## SPR EA1N and EA2 PROJECTS

### DEADLINE 8 – SASES COMMENTS ON APPLICANTS D7 RESPONSES TO SASES D5 SUBMISSIONS

Interested Party: SASES PINS Refs: 20024106 & 20024110

Date: 25 March 2021 Issue: 4

■ Figure 2 - Monopole Converter Arrangements

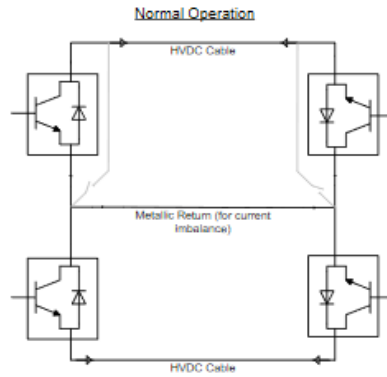
<p>detail in the context of the overall project efficiency and economy. The lack of investigation of possible cable route to Leiston Old Airfield was a choice for which the Applicant was responsible, with NGV having taken a more positive approach.</p> <p>SASES reiterates that it does not accept that the Grove Wood site is the most suitable of those available to the Applicant, and that the site selection investigation area was incorrectly restricted to sites in close proximity to the 400kV overhead lines when it is only the NGET substation itself that needs to be so located.</p>
<b>2.5 Deadline 5 – BEIS OTNR Pathfinder Clarification Note</b>		
1	<p>BEIS OTNR Pathfinder Clarification Note</p> <p>Use of Bipole technology and EA1 trench configuration</p>	<p>SASES is concerned that the Applicants comments on Bipole cable technology are based on the original EA3 documentation which may no longer be fully applicable.</p> <p>The Discharge documentation for EA1 shown on page 24 of <a href="http://content.yudu.com/web/2it8t/0A4226m/CMS/html/index.html?page=24">http://content.yudu.com/web/2it8t/0A4226m/CMS/html/index.html?page=24</a> clearly shows the cable configuration for EA3 as being that shown in Figure 1 below, with a total of three ducts/cables in one trench, which SASES understands to be indicative of a Bipole connection for the EA3 windfarm.</p> <p>The earlier EA1 and EA3 documentation did refer to Symmetric Monopole connections for EA3 using a trench configuration as shown in Figure 2, with two of the four trenches reserved for ‘future projects’ allocated to EA3, and each trench containing two ducts/cables as is understood appropriate for Symmetric Monopole. But following relaxation of the Regulation 29 requirement in the EA1 DCO the total number of trenches to be built by the project was reduced to three, as shown in Figure 1, and this would seem to be incompatible with the use of Symmetric Monopole for EA3 as only one trench remains available for this project.</p> <p>The Bond Dickinson letter to BEIS of 27 June 2016 (copy below) clearly states on page 2 (SASES emphasis) that “<i>East Anglia ONE propose to lay six onshore cables, in two groups of three, within two trenches and <b>three ducts within a further trench that will be used by East Anglia THREE</b> when that project comes to lay its onshore cables.</i>”</p> <p>SASES has been unable to find any further details in the published EA3 documentation and would welcome clarification of the means of connection to be used by EA3.</p> <p>Figures 3 and 4 below, taken from a report prepared for Ofgem <a href="https://www.ofgem.gov.uk/ofgem-publications/59247/skm-report-calculating-target-availability-figures-hvdc-interconnectors.pdf">https://www.ofgem.gov.uk/ofgem-publications/59247/skm-report-calculating-target-availability-figures-hvdc-interconnectors.pdf</a> support SASES understanding of the cabling requirements for HVDC Symmetric Monopole and Bipole.</p>

If a fully rated HVDC cable is installed instead of a return conductor, then two converters per pole can be utilised to double the power transferred using opposing voltage polarities. However, if a cable or converter is faulted then the whole transfer capability is lost.
